ND-19-1539  
10 CFR 50.90  
10 CFR 52.63

**Southern Nuclear Operating Company**  
**Vogtle Electric Generating Plant Units 3 and 4**  
**Supplement to Request for License Amendment and Exemption:**  
**Automatic Depressurization System (ADS) and Core Makeup Tank (CMT)**  
**Design Parameters (LAR-19-009S1)**

Figure 1: Excerpt from Vogtle 3&4 UFSAR Figure 6.3-1 (Sheet 1 of 3)

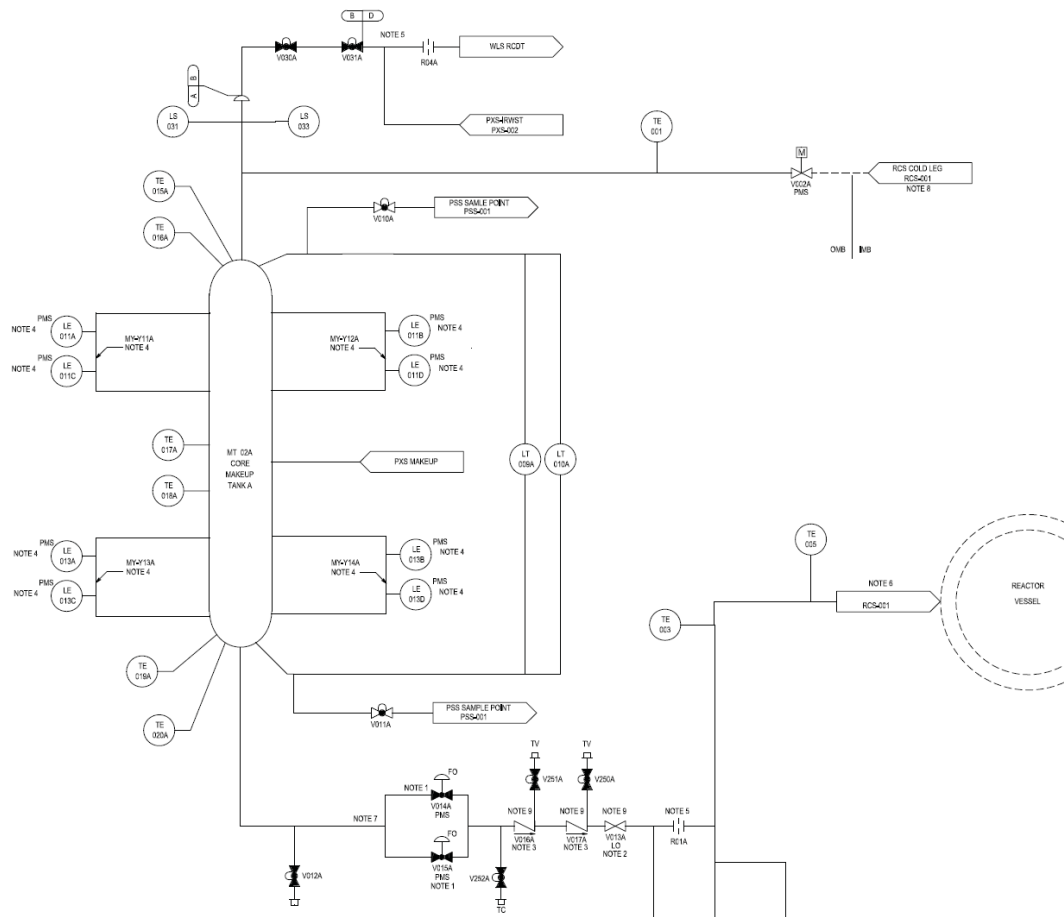
Specifically, one of the proposed changes addresses the core makeup tank (CMT) minimum volume and associated surveillance requirements. On a public call with the NRC Staff on December 5, 2019, additional information was requested regarding compliance with Technical Specification (TS) 3.5.2, Core Makeup Tanks (CMTs) – Operating, during conditions related to the volume of noncondensable gases in the CMT inlet line which cause the high-point water level to drop below the sensor. In particular, the Staff was concerned about an indeterminate volume in the CMT which may lead to an indeterminate compliance with the safety analysis and possible necessary entry in TS 3.5.2 Actions Condition E along with Condition D.

The CMT volume is confirmed by the use of the high point gas accumulation instrumentation. The CMT wide range level instrumentation is intended to provide indication of level (volume) for the span of tank height. Due to the arrangement of the level taps on the CMT and accounting for instrument error and uncertainties, the wide range level instrumentation cannot confirm a volume of 2487 ft<sup>3</sup>. It should be noted that the upper taps for the wide range nozzles are not at the uppermost portion of the CMT due to other tank features (inlet nozzle, internal connections, etc.).

The amount of measurable volume with the wide range level, accounting for error and uncertainty, is approximately 2475 ft<sup>3</sup> for the most limiting as-built tank.

The CMT arrangement is depicted in Figure 6.3-1 (Sheet 1 of 3) of the Vogtle 3&4 UFSAR. The high point gas accumulation instrumentation is approximately 28" above the inlet nozzle of the CMT and, therefore, when a gas accumulation alarm is not present, the entire CMT is full. If gas were to accumulate in the inlet line high point, it would generate an alarm. The expected operator action is to vent the gas to clear the alarm and re-confirm adequate CMT volume.

Based upon the information provided regarding the physical arrangement of CMT gas accumulation instrumentation and CMT wide range level taps, when a high point gas alarm is present and the CMT wide range level is at 100%, the volume of the CMT is indeterminate, but there is certainty that the CMT water volume is greater than 2475 ft<sup>3</sup>. However, without a significant amount of accumulated gas and a leak mechanism from the CMT, the water volume would not fall below the inlet nozzle (or vertical inlet piping before the tee). Thus, the expectation is that the reduction of volume in the CMT inlet line due to accumulation of non-condensable gas would be a slowly developing event and venting of the gas intrusion volume within the 24-hour Completion Time of Condition D would result in restoration of CMT level prior to reduction below the safety analysis assumed volume of 2487 ft<sup>3</sup>.

With Surveillance Requirement (SR) 3.5.2.2 removed, the only SR not met is volume of noncondensable gases, old SR 3.5.2.4 (proposed SR 3.5.2.3), and thus Condition D would be entered. Since the unexpected potential for not maintaining the safety analysis assumption of CMT volume would not be discernable until a level below 2475 ft<sup>3</sup>, the existing potential for entering Condition E (i.e., inoperable for reasons other than noncondensable gas accumulation) would be expected to be inconsequential since as noted above, the leakage requirements of TS 3.4.7 would generally be expected to be more limiting. Thus, entering only Condition D is appropriate during this indeterminate volume condition since as noted on page 10 of 16 of Enclosure 1 to letter ND-19-1142, "This is acceptable because this Action is entered with greater remaining volume in the CMT, and the 24-hour Completion Time would be expected to lead to restoration in a similar time frame as waiting to enter until the lower volume is reached and providing for restoration in 8 hours. Further, there is no mechanism that drains water below the top nozzle of the CMT."
